**Special Design Review Committee
Of the Saint Paul Heritage Preservation Commission
445 Smith Avenue N.
September 2, 1025
10:00 AM**

**Special Design Review Committee
of the Saint Paul Heritage Preservation Commission
445 Smith Avenue N
September 2, 2015**

Summary of Changes—HPC Design Review
445 Smith Ave/Stone Saloon
(comparing Aug. 27 and Oct. 8, 2015 submissions)

**Alterations,
Stone Saloon Submission
to the Historic Preservation Commission
September 22, 2015**

FIRST FLOOR PLAN

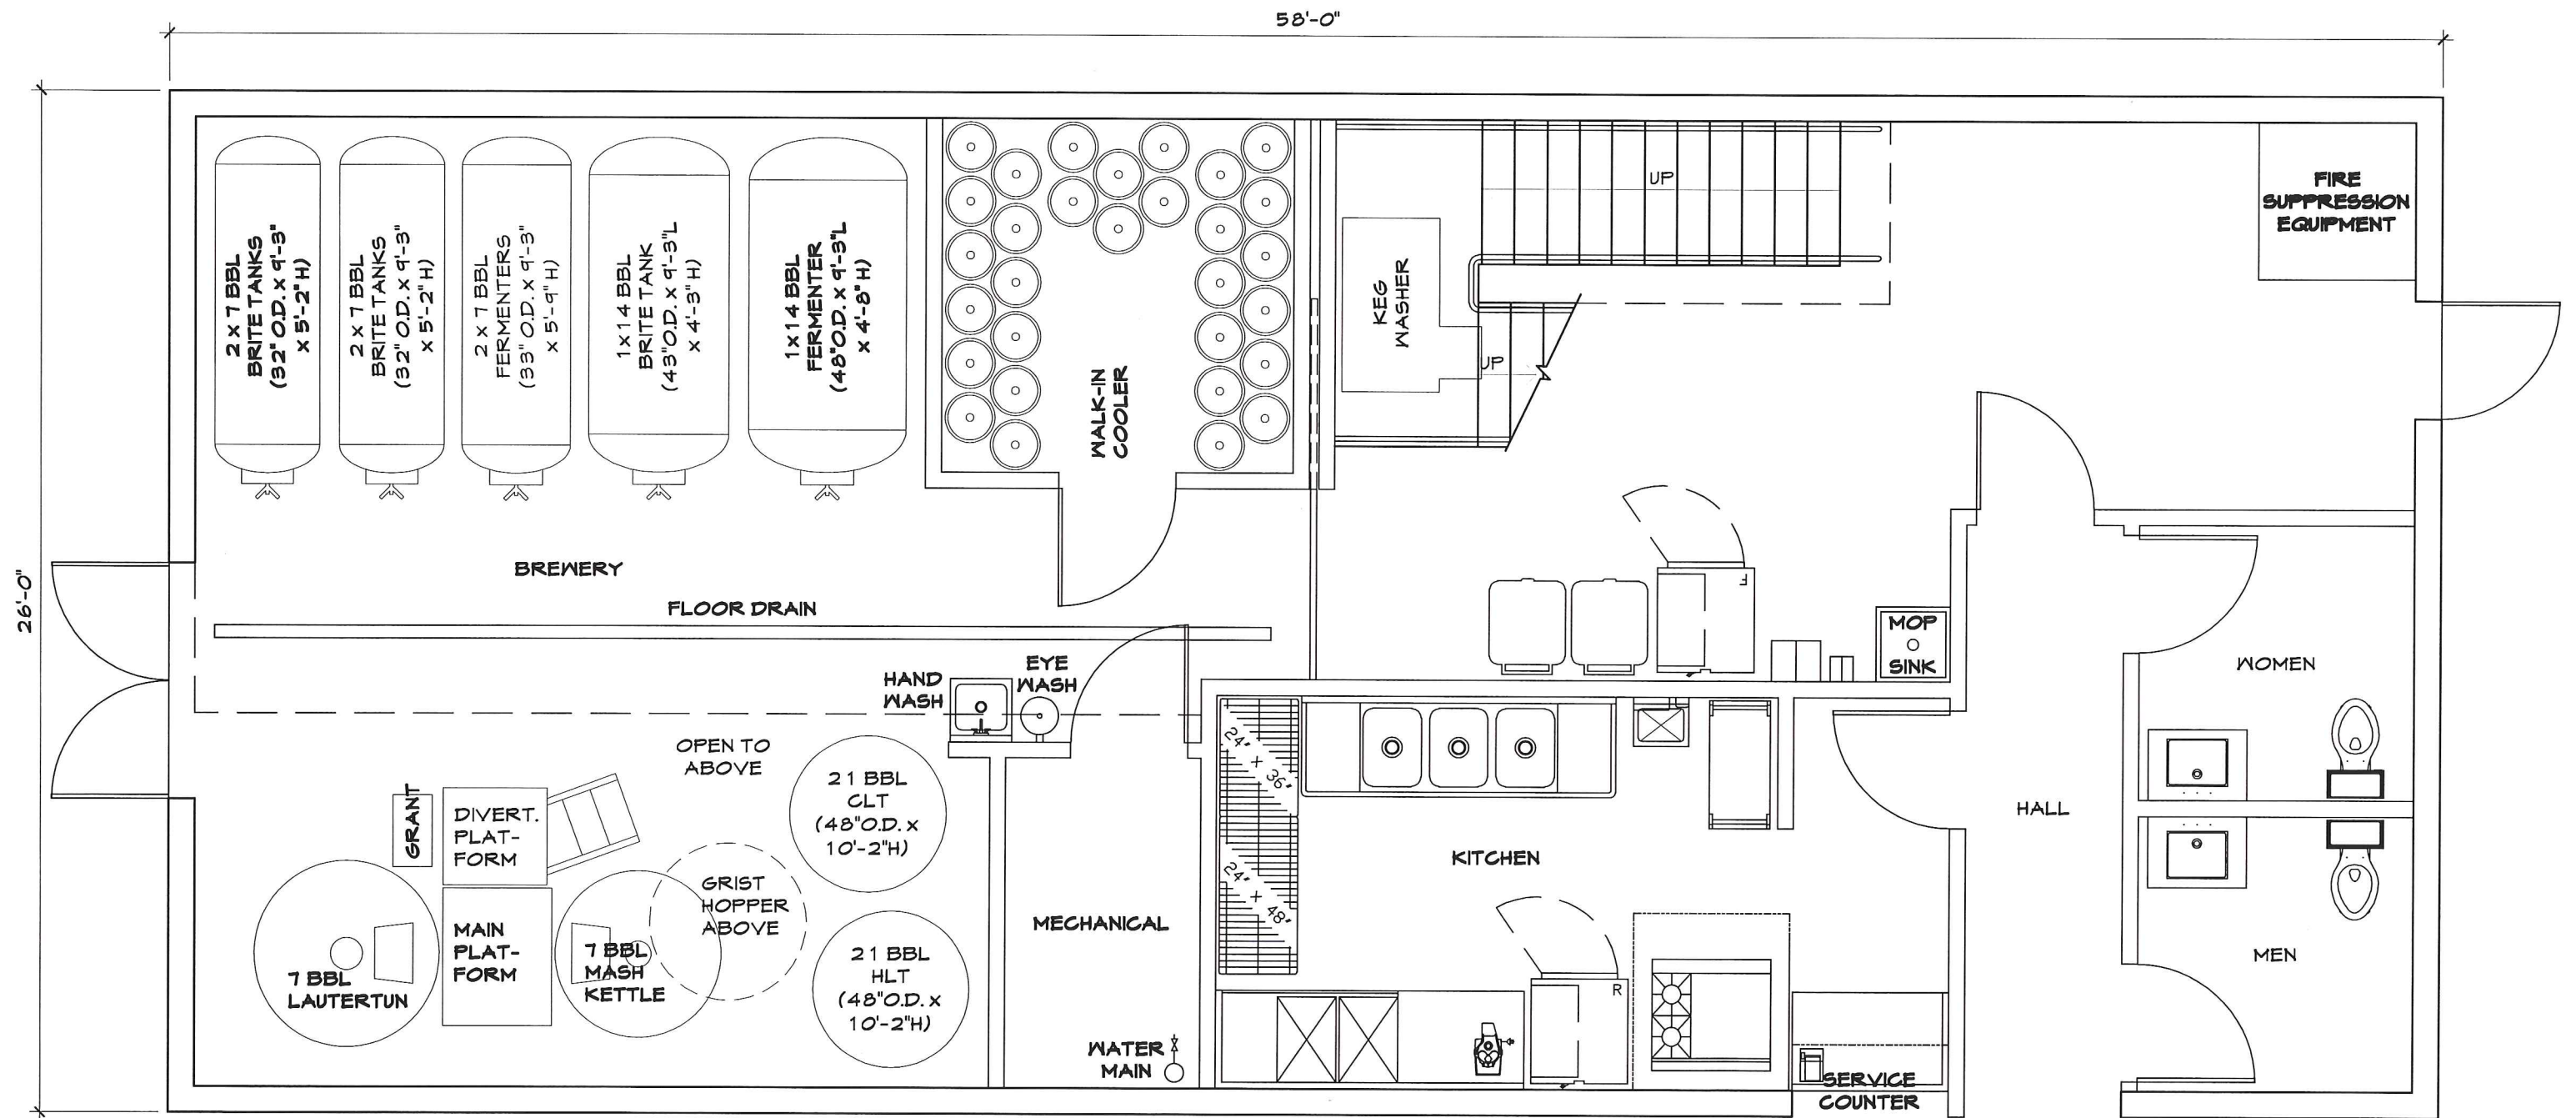
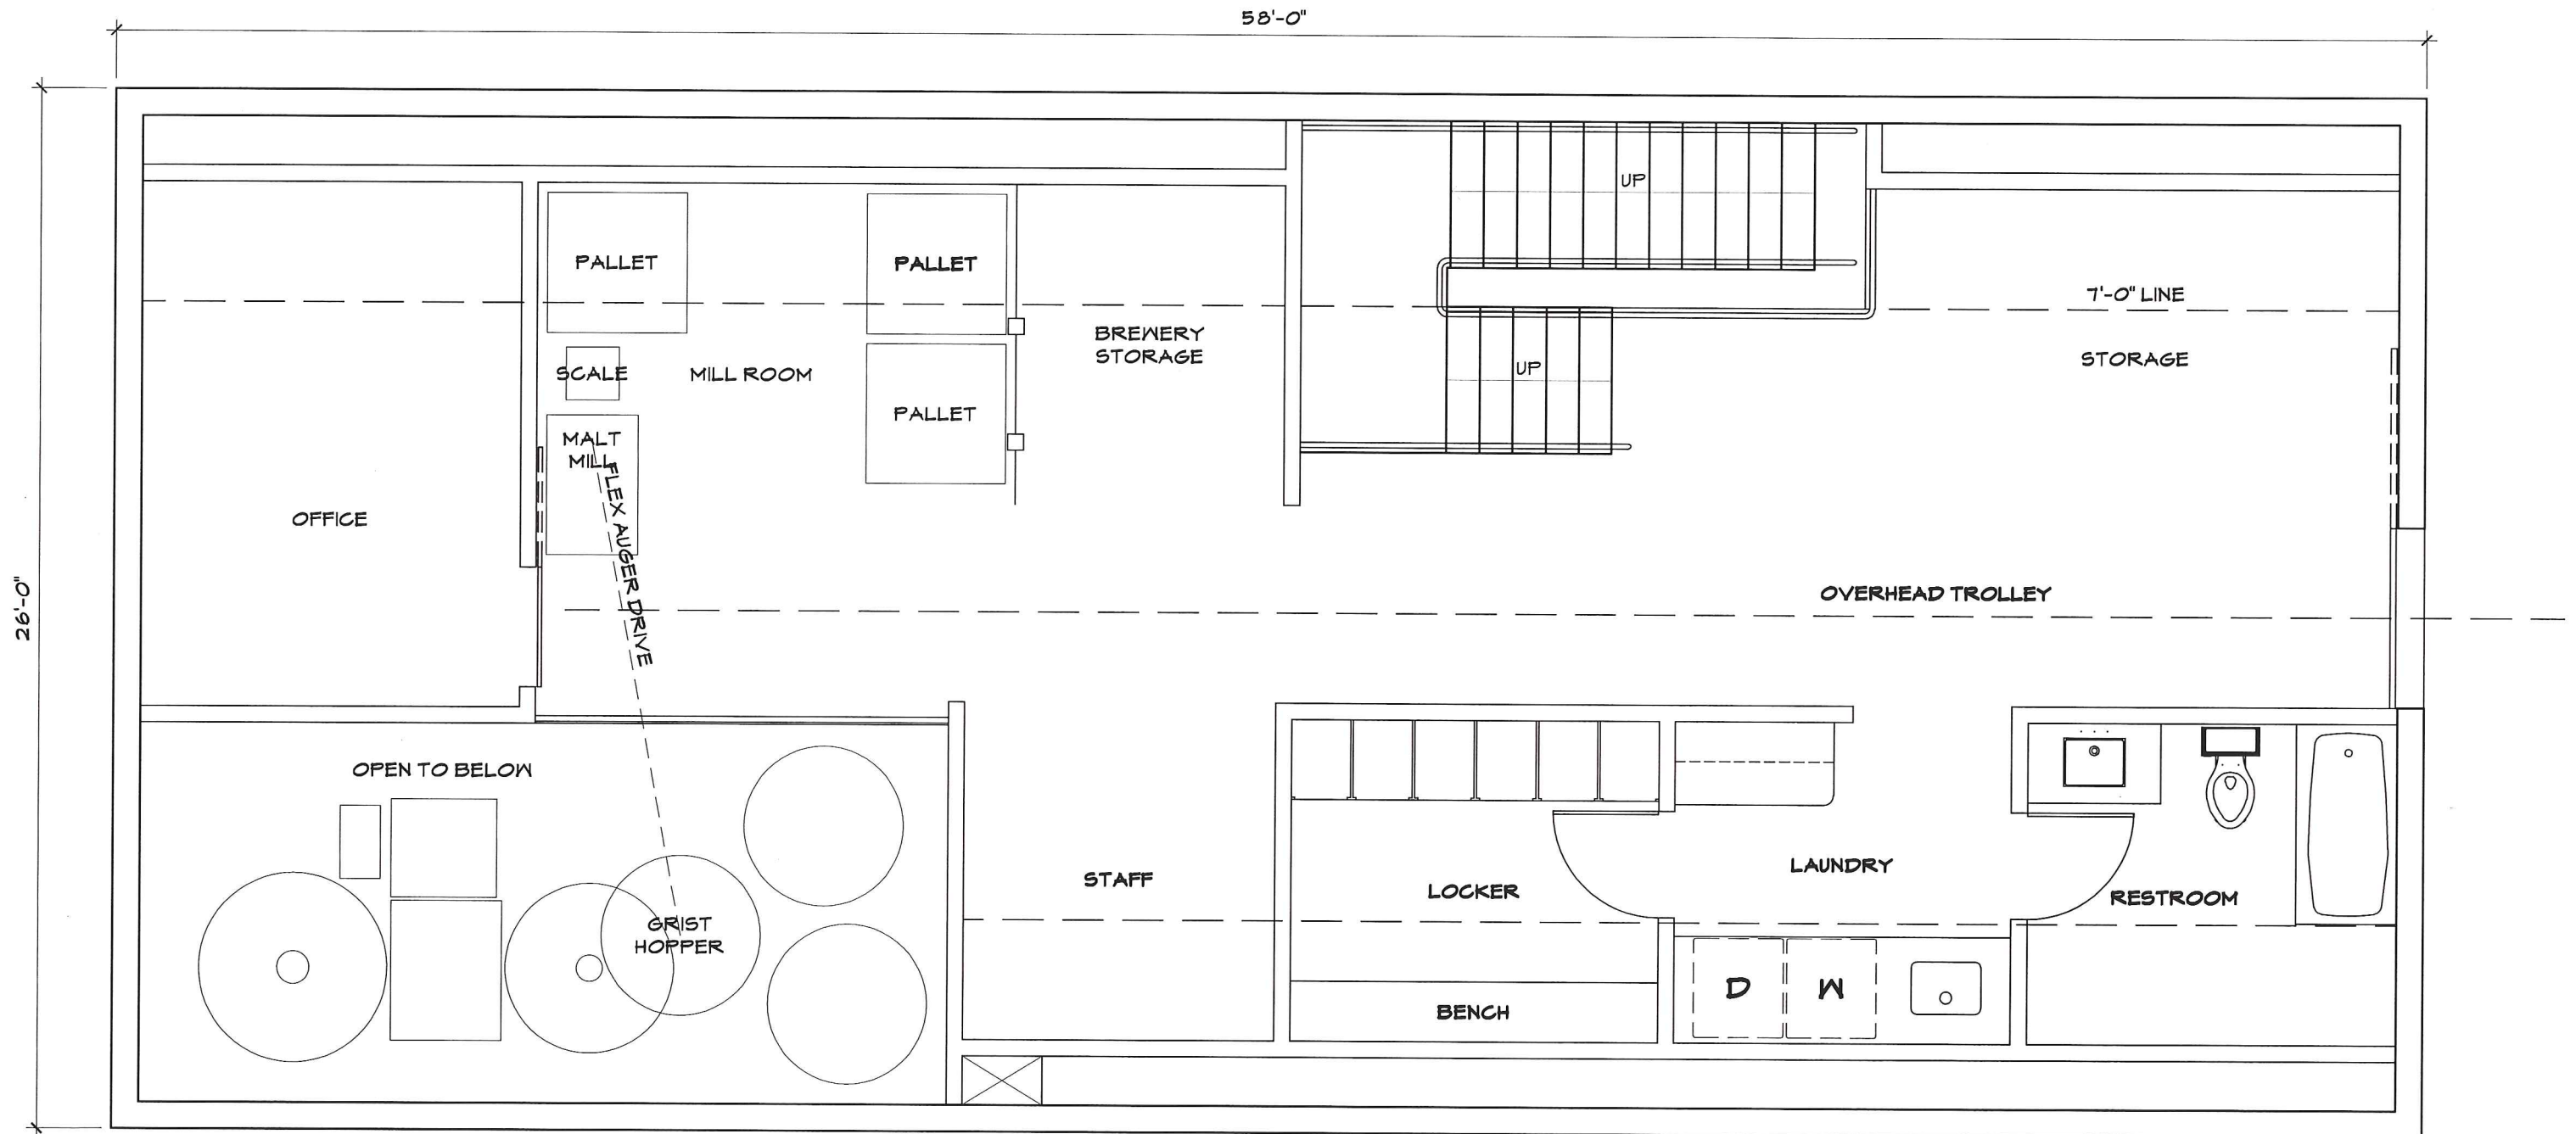
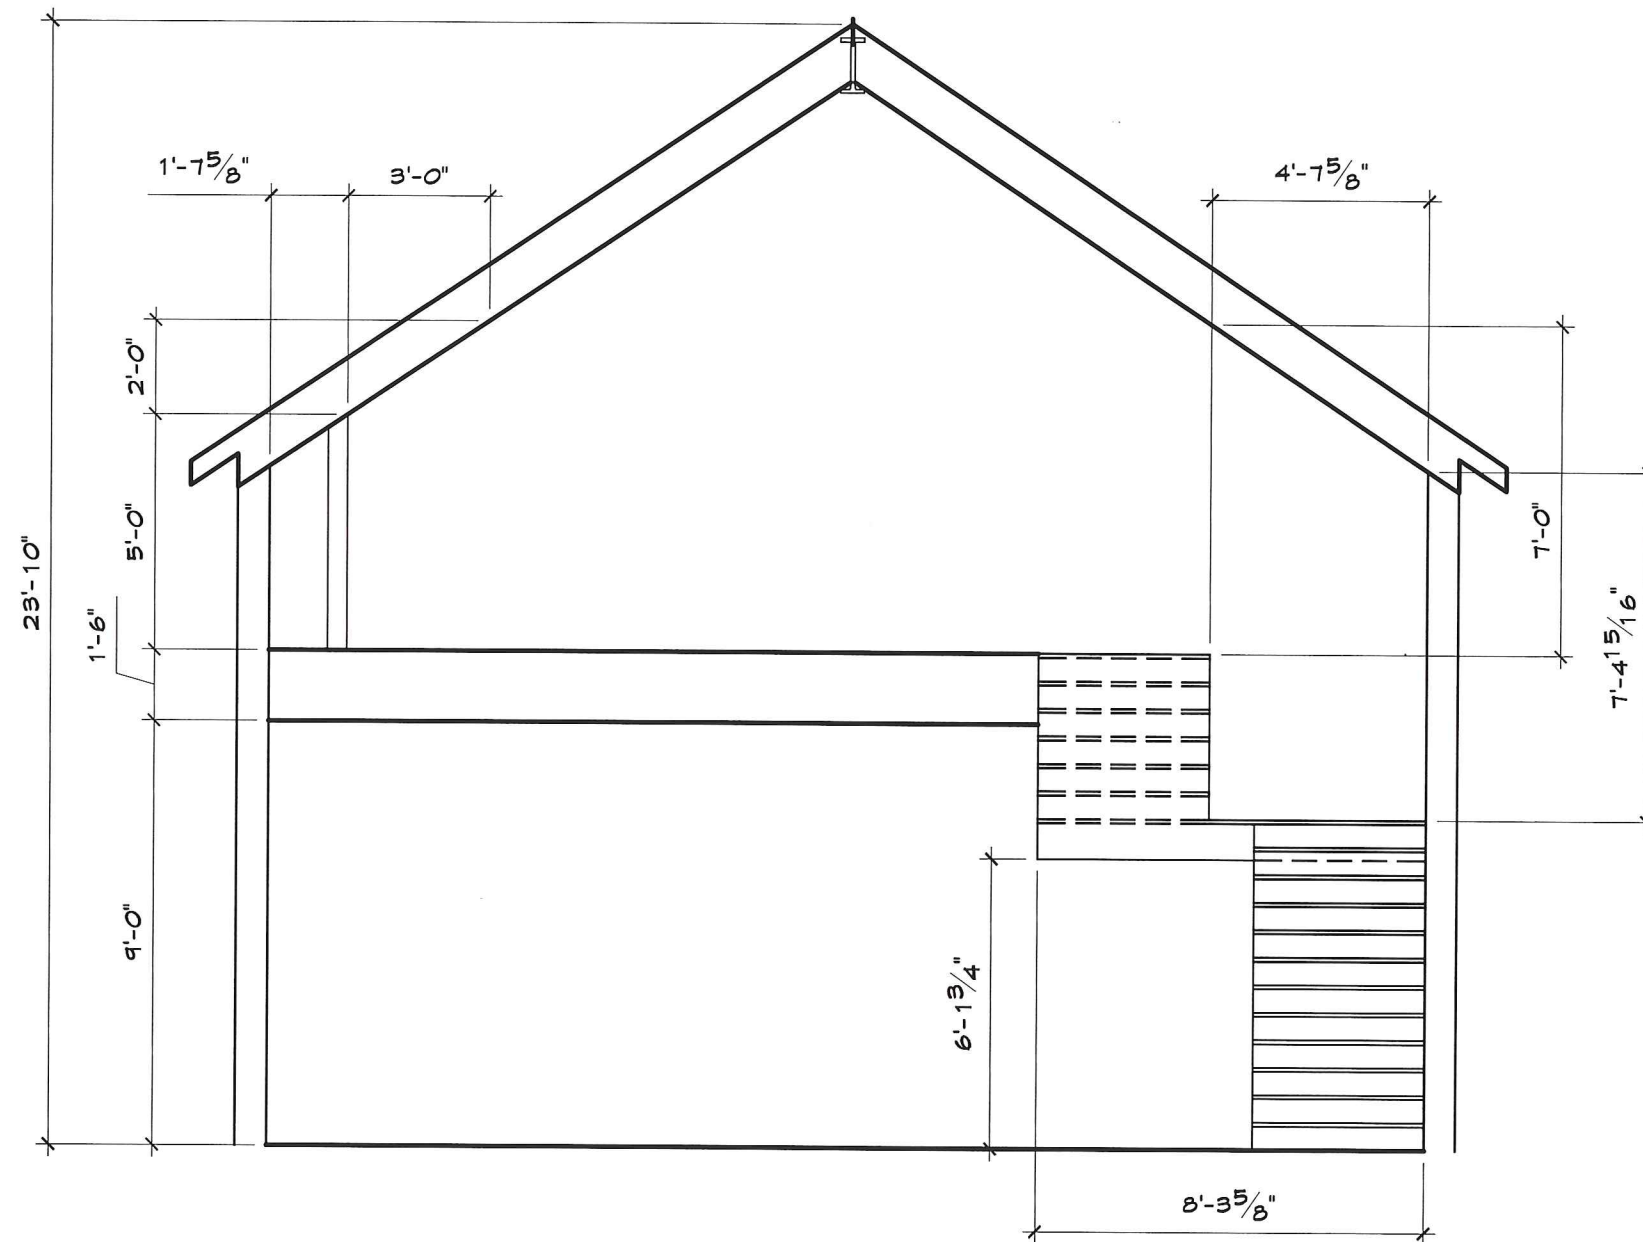
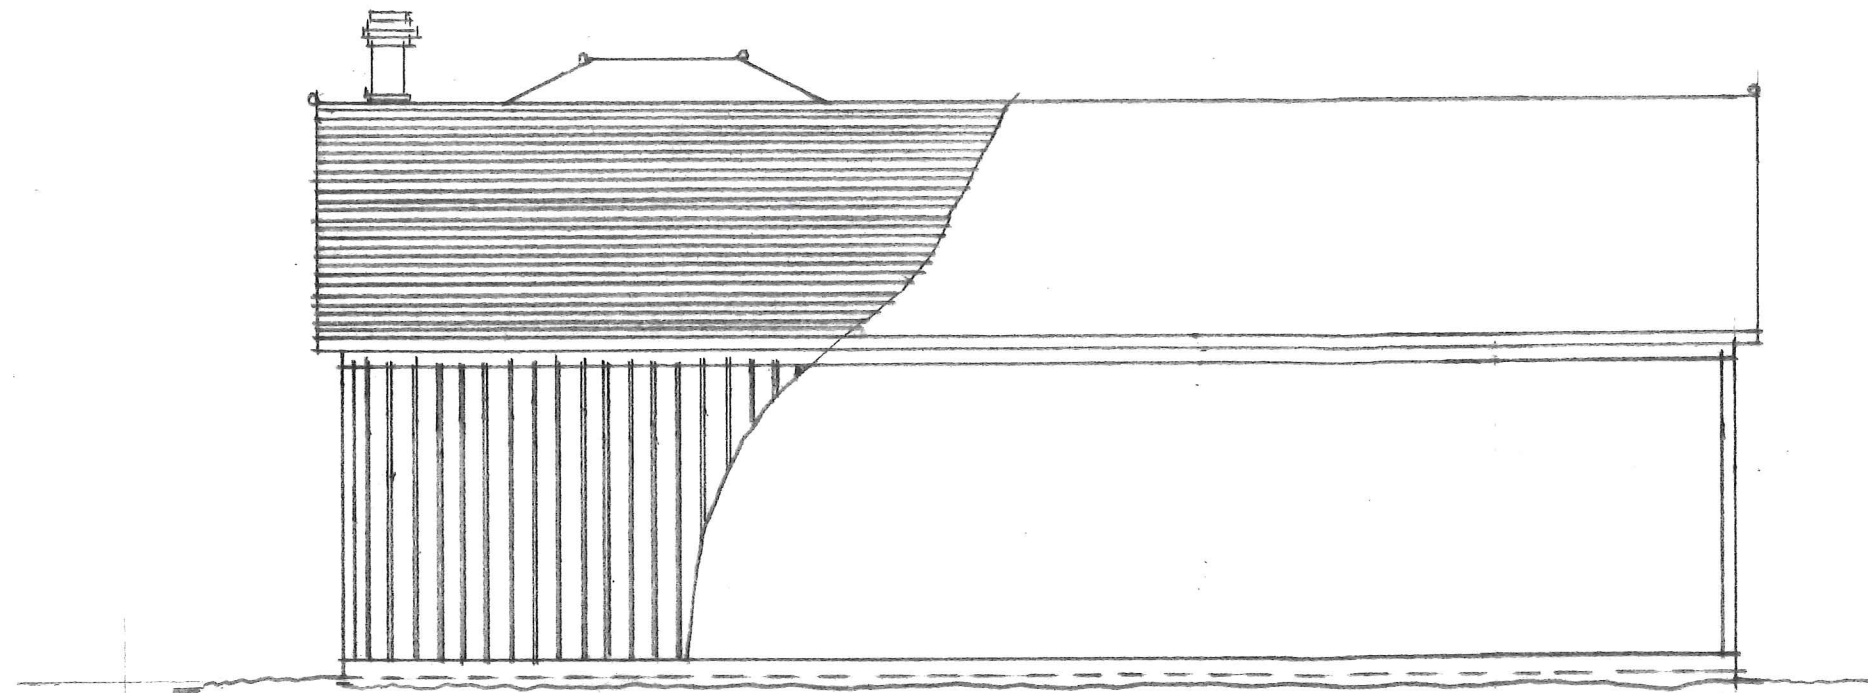
- At least one member of the DRC encouraged us to show another option for the brew barn that lowered the eave height to the approximate height as the rear wood frame addition. To the extent this change reduced the usable space of the brew barn's second story, it was suggested that the building's footprint could be enlarged. The revised site plan shows this new option as a dotted line to the south of the brew barn increasing the length (but not the width) of the "Option 2" building from 48 to 58 feet. (see further discussion below).

- One member of the DRC asked us to explore an alternative design for the brew barn incorporating lower roof eaves, and expanding the footprint as necessary to make up for any loss of usable space on the second level. To satisfy this request, we reconvened the kitchen designer, brewery designer and general architect and worked through several additional iterations of the design which variously incorporated steeper roof pitches and/or a lowered roof peak in order to lower the roof eaves. A recommendation was also made at the DRC meeting to narrow the vestibule between the rear addition and the brew barn and make it more transparent. Elements of the resulting alternative ("Option 2") include:

- We were asked to explore and present an alternative design incorporating lower roof eaves, expanding the footprint as necessary to make up for the lost usable space on the second level. The kitchen designer, brewery design and general architect met several times and cycled through several potential iterations of the brew barn incorporating these objectives. Elements of the resulting alternative include:

1. Removing kitchen equipment and functionality from the vestibule and reorienting the kitchen on a North/South axis entirely within the lengthened brew barn space.

2. Moving from a 6/12 roof pitch to a 8/12 roof pitch in order to lower the eaves.
 3. We explored lowering the roof peak, but when this was done to any material extent, the second floor became largely unusable, requiring a much greater expansion of the footprint of the building. Accordingly, in an effort to balance these concerns, Option 2 has the same peak height as Option 1.

4. We have shown the vestibule as transparent glass. To further enhance this transparency, Option 2 removes the kitchen equipment from the vestibule and lowers the vestibule dividing wall to a half-wall.

5. The Option 2 vestibule is narrower than the Option 1 vestibule to further differentiate the rear addition and the brew barn.

6. The cumulative effect of these design changes increases the length of the Option 2 brew barn by 10' on the North-South axis, making the building 26'x 58'.
- Having thoroughly explored Option 2, the owner continues to favor Option 1 as originally proposed. Any benefit achieved by lowering the eaves appears to be largely outweighed by the need to substantially lengthen the building's footprint to the south—the area of greatest visibility from the public right of way. Option 1 is somewhat more hidden from public view, and more effectively keeps the spotlight on the historic stone structure. Moreover, preliminary calculations indicate that the increased manufacturing square footage in Option 2 would require one additional off-street parking stall, which the owner is currently unable to provide.

1. To orient the kitchen in a North/South axis, rather than a East/ West axis. (done)
 2. To lower the roof eave, this alternative moves from a 6 / 12 roof pitch, to a 8 / 12 roof pitch. (done)

3. We explored lowering the roof peak, but found that when this was done to any material extent, the second floor became largely unusable. (not done)
 4. To make the connector between the frame part and brew addition more transparent (glass). With that goal in mind, the alternative also removes kitchen equipment from this area. (done)

5. The cumulative effect of these design and functional changes increase the size of the building foot print by 10' on the North-South axis, making the building 26'x 58'. (done)
